Subject: MHI's Response to US-APWR DCD RAI No. 545-4290 Rev. 1

Response to Request for Additional Information
No. 545-4290 Revision 2

US-APWR Design Certification

SRP SECTION: 04.03 – Nuclear Design

Figure 04.03-56.1 Structure of Neutron Reflector and Core Barrel

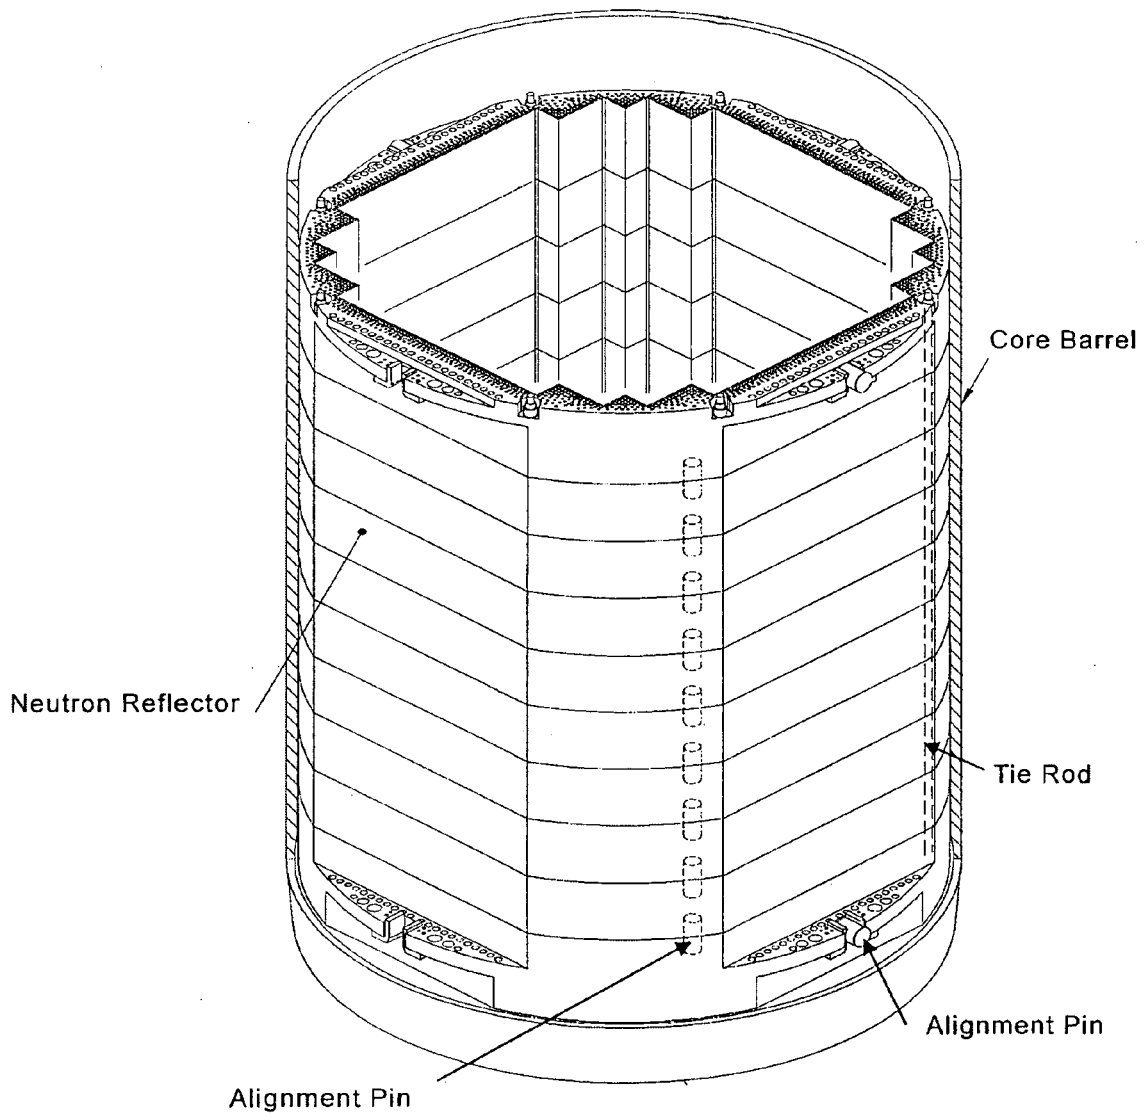
The former-plates between the baffle and core-barrel of Figure-A-2 of MUAP-09018 can have a significant effect on the vessel fluence prediction. Provide an axial and radial description of the former plates (if they are present in the US-APWR) and any other structures/supports located in the region between the core and the vessel. Have the former-plates and all supports/structures between the core and vessel been included in the calculational models? If not, update the models to include these effects and provide the resulting changes in the calculated vessel fluence. The uncertainty and bias introduced by any approximations in representing these structures should also be determined and incorporated in the fluence analysis.

The design of the US-APWR core internals incorporates the neutron reflector but not the former-plates. As shown in Figure 04.03-56.1, the design includes tie rod and alignment pins that are modeled as the same stainless steel as the neutron reflector.
